ST. TAMMANY PARISH

**Addendum No.:** 2

**Bid#:** 327-00-18-50-2

**Project Name:** Safe Haven Renovations Quad A

M1.02

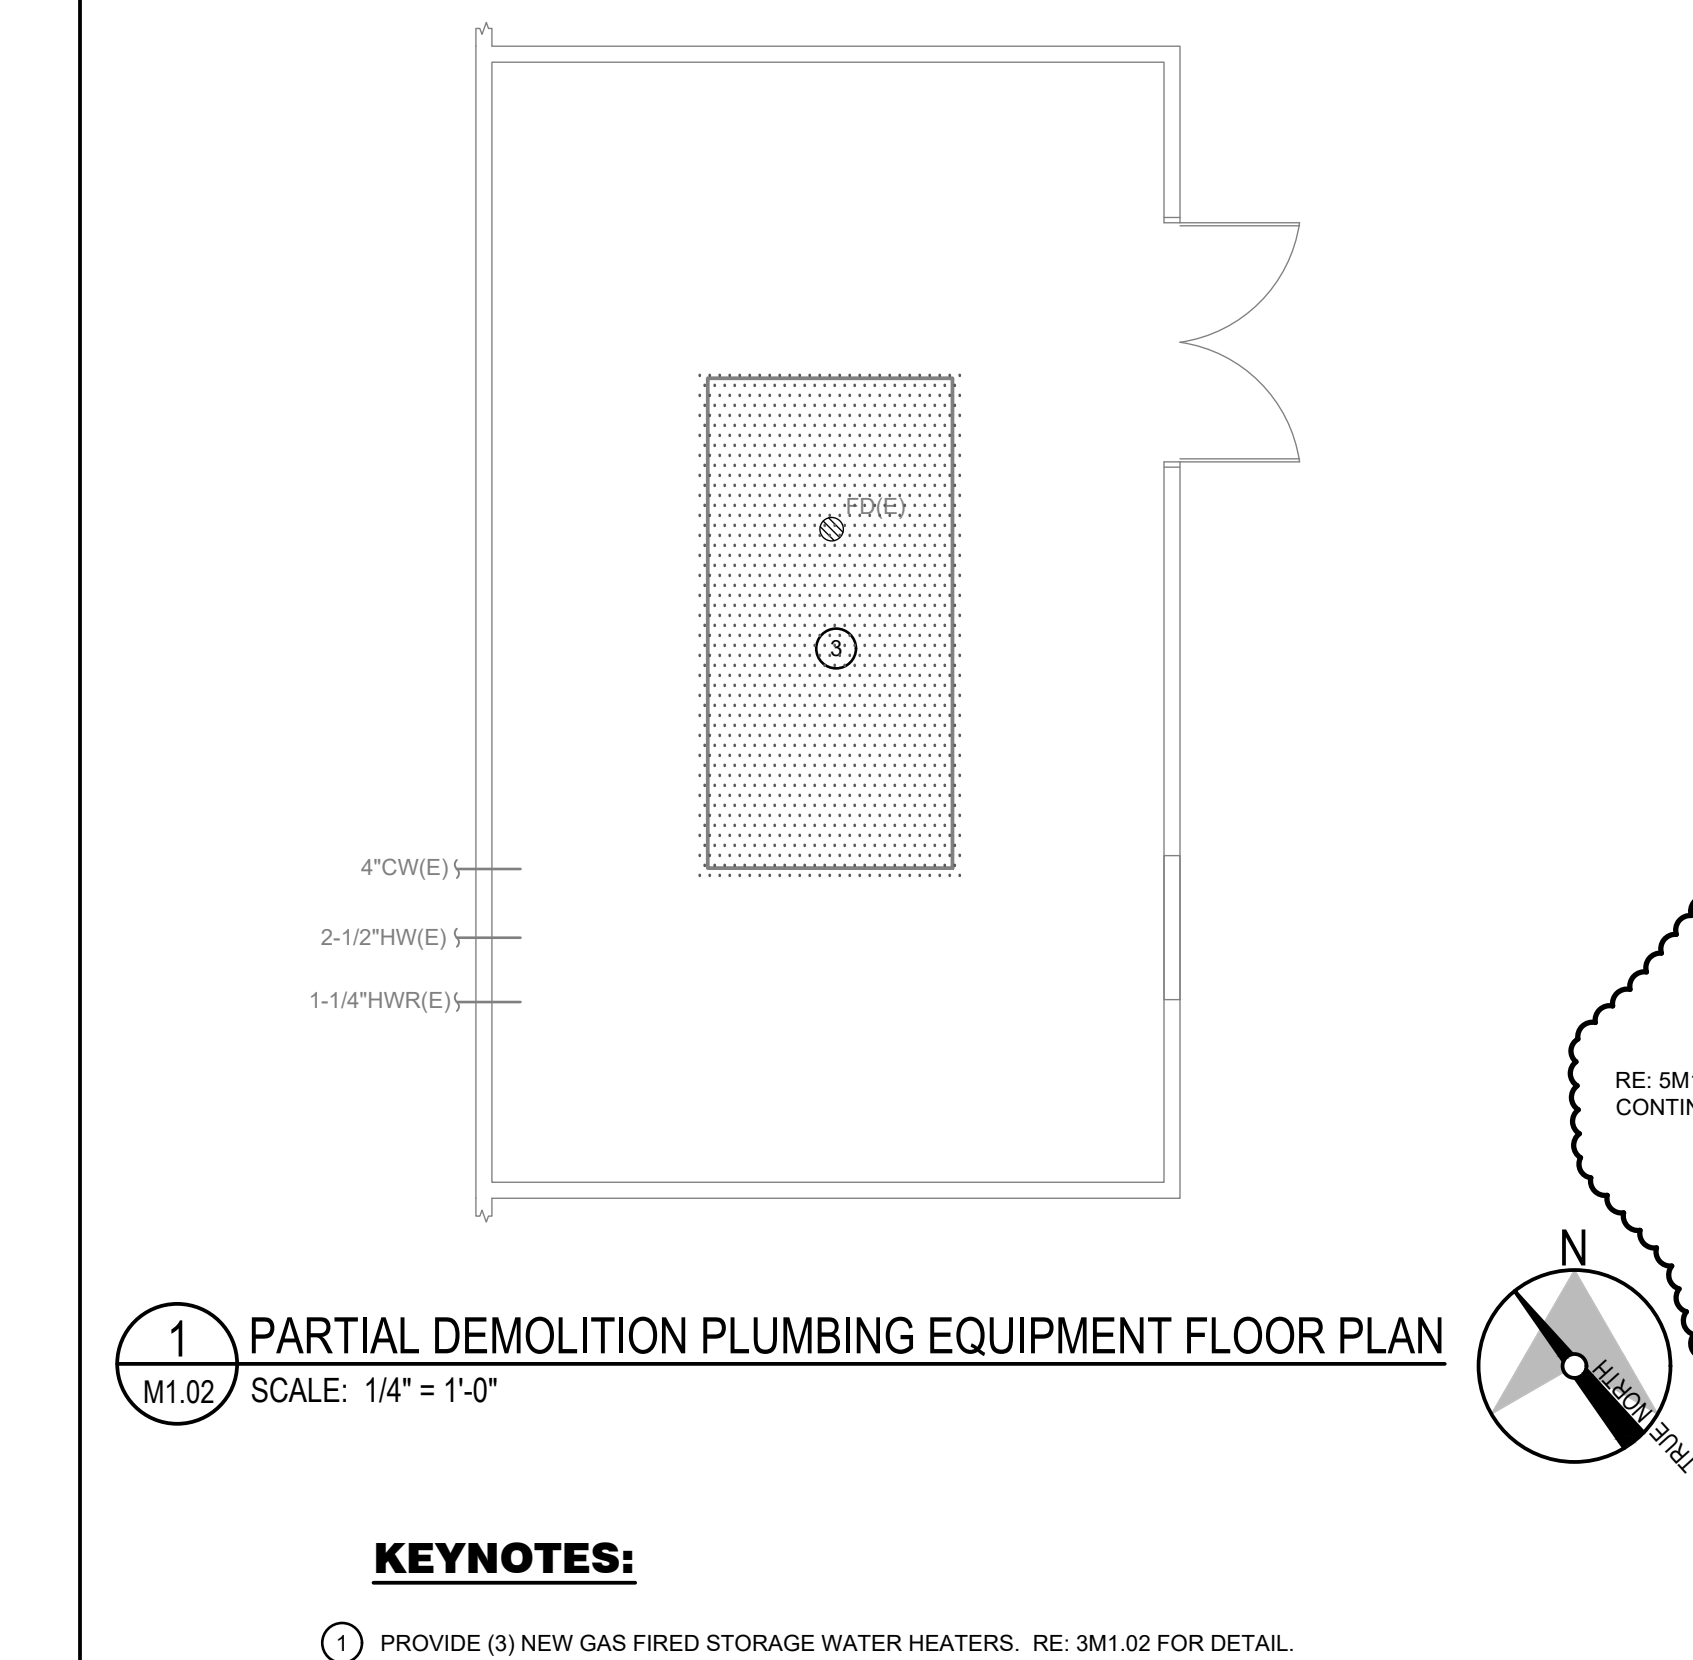
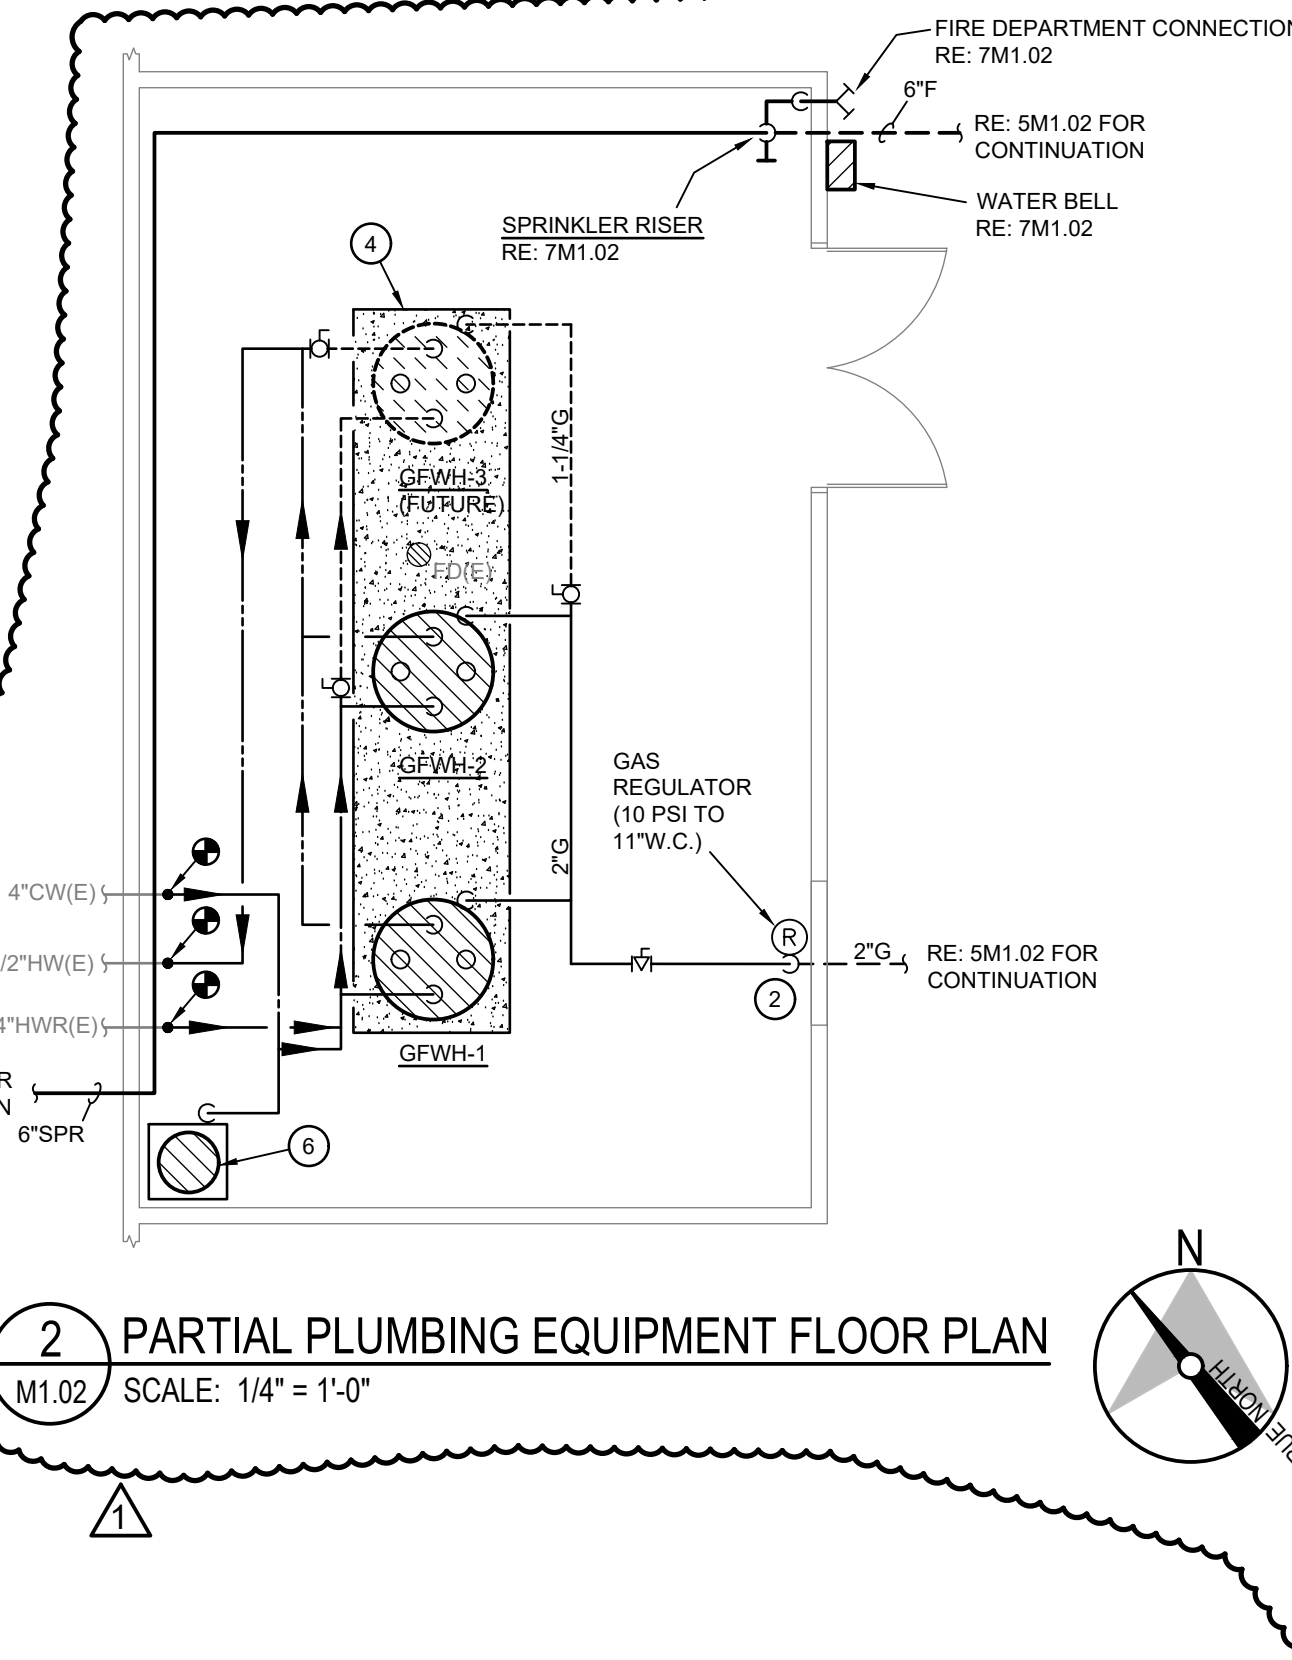
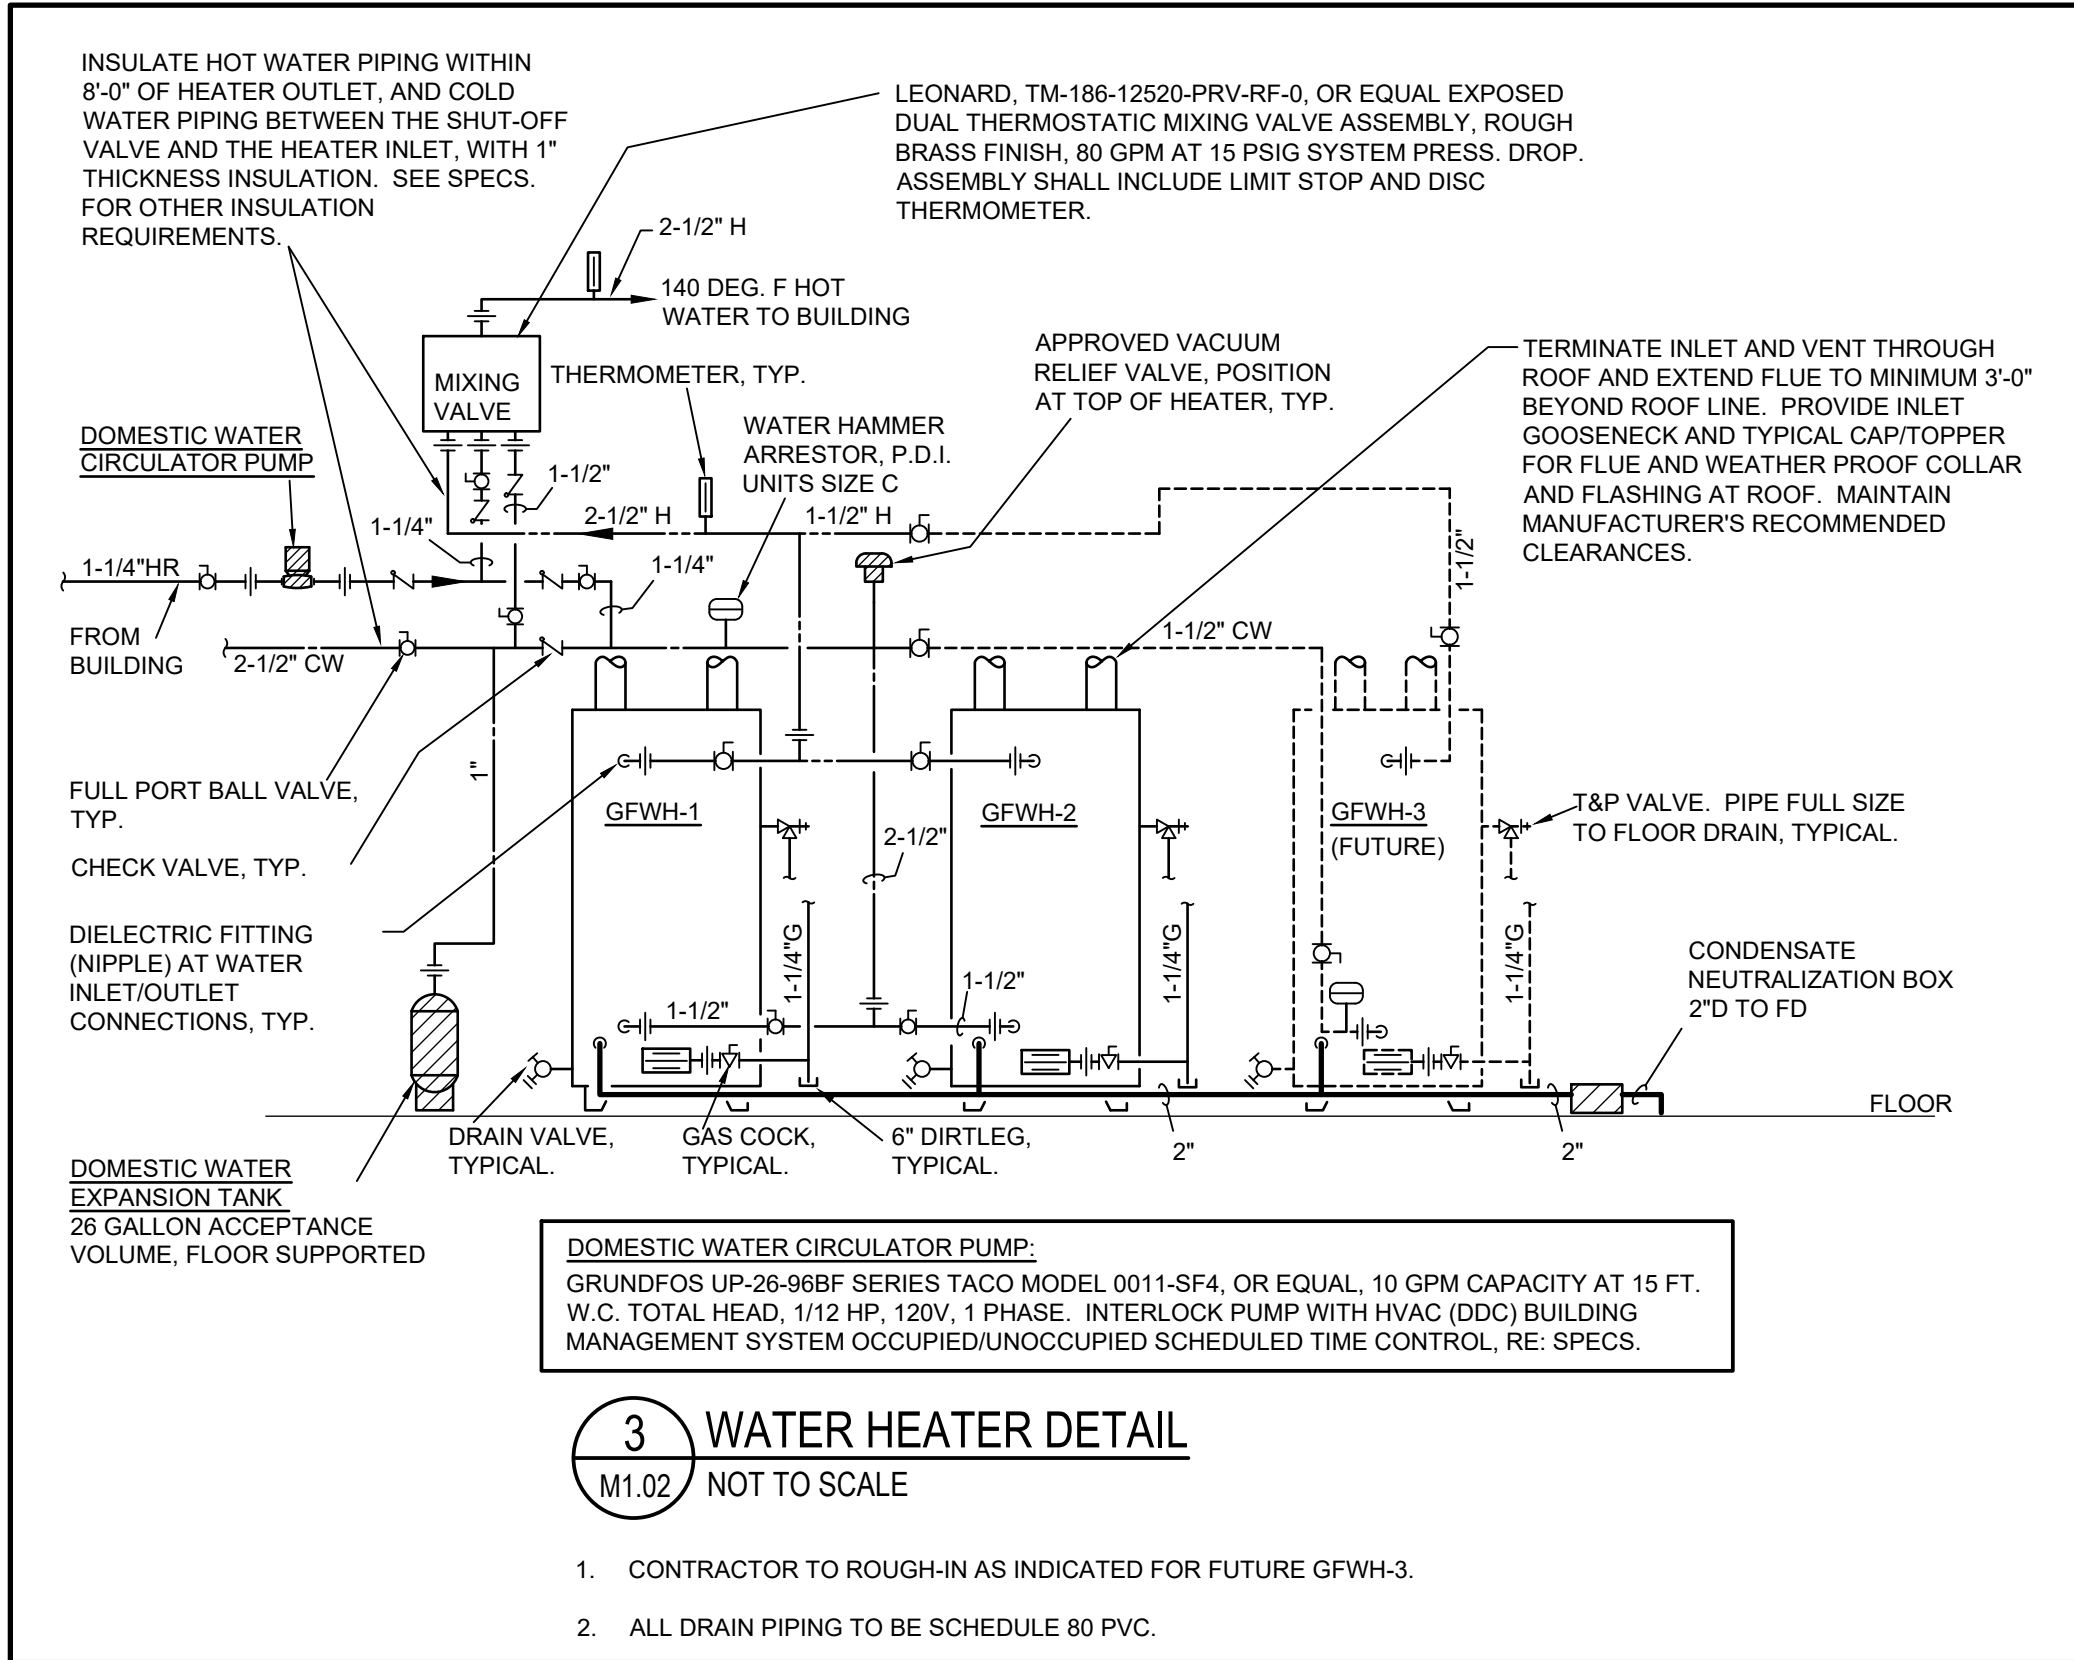
12. At Section 11 – Drawings, **DELETE** sheet M1.02 and **ADD** sheet M1.02 Rev.1 dated 6 May 2019. Updated water heater details to comply with new specification of the water heaters, added notes to the underground gas pipe routing for clarity purposes and revised the plumbing riser diagram to include the new electric water cooler. (Attached)
